SUBJECT: MONTICELLO NUCLEAR GENERATING PLANT - INTERIM STAFF  
EVALUATION RELATING TO OVERALL INTEGRATED PLAN IN RESPONSE  
TO PHASE ONE OF ORDER EA-13-109 (SEVERE ACCIDENT CAPABLE  
HARDENED VENTS) (TAC NO. MF4376)

INTERIM STAFF EVALUATION  
BY THE OFFICE OF NUCLEAR REACTOR REGULATION  
RELATED TO ORDER EA-13-109 PHASE 1 MODIFYING LICENSES  
WITH REGARD TO RELIABLE HARDENED  
CONTAINMENT VENTS CAPABLE OF OPERATION UNDER  
SEVERE ACCIDENT CONDITIONS  
NORTHERN STATES POWER COMPANY - MINNESOTA  
MONTICELLO NUCLEAR GENERATING PLANT  
DOCKET NO. 50-263

**Figure 1 [of the OIP]: HCVS Exhaust Vent**

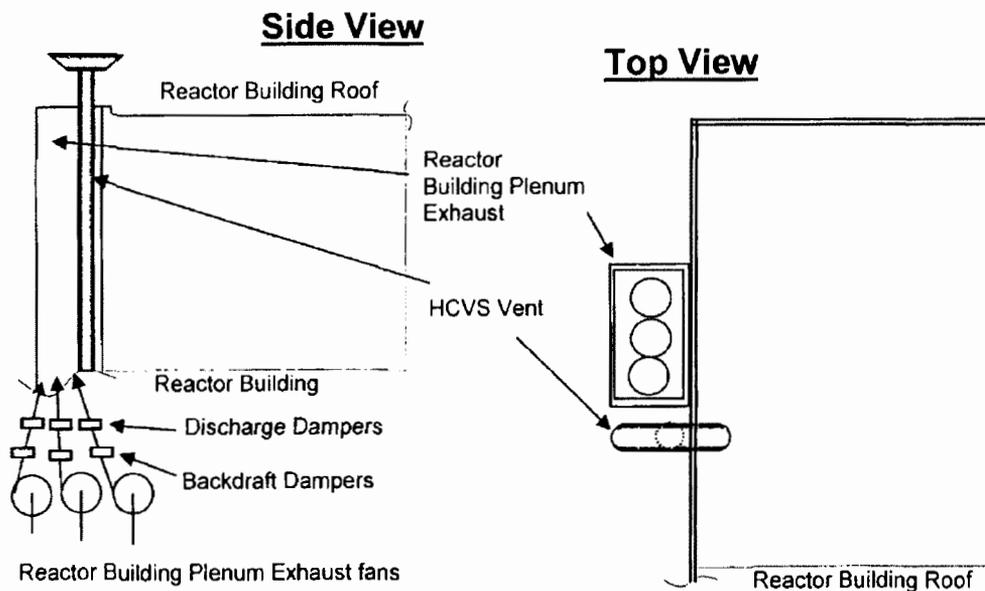
The HCVS discharge path is currently routed next to the Reactor Building plenum exhaust with the vent exhaust 3 ft. above the top of the Reactor Building plenum exhaust stack (see Figure 1 [of the OIP]). The vent exhaust is above the main plant structures. The vent is located greater than 100 ft. above ground level, providing an elevated release point that will not affect personnel staging any portable equipment needed for the Beyond Design Basis External Event (BDBEE).

The HCVS exhaust vent is not near the Reactor Building intake, control room intake, or the emergency response facilities, but is next to the Reactor Building plenum exhaust path. The Reactor Building plenum exhaust fans will be without a power source in a station blackout.

There are two dampers after each Reactor Building plenum exhaust fan - a backdraft damper and discharge damper. The discharge damper will close on loss of power associated with the station blackout and the backdraft damper will close on loss of Reactor Building exhaust flow. Both dampers are designed to prevent reverse flow, and therefore, prevent HCVS gases from entering the Reactor Building via the plenum room. Safety related dampers also isolate the plenum room from the rest of the Reactor Building. The "T" at the top of the vent will also be removed and replaced with a straight exit with a weather cap. This change will direct the vented gases upward and away from the plant.

Therefore, the existing HCVS vent configuration is an acceptable alternative to JLD-ISG-13-02 and NEI 13-02.

As far as the HCVS effluent release point is concerned, the licensee identified an alternative to the effluent release point described in the guidance provided by NEI 13-02, Section 4.1.5.2.2.

Therefore, MNGP's HCVS existing effluent release point location appears to be an acceptable alternative to the release point described in the guidance provided by NEI 13-02, Section 4.1.5.2.2.
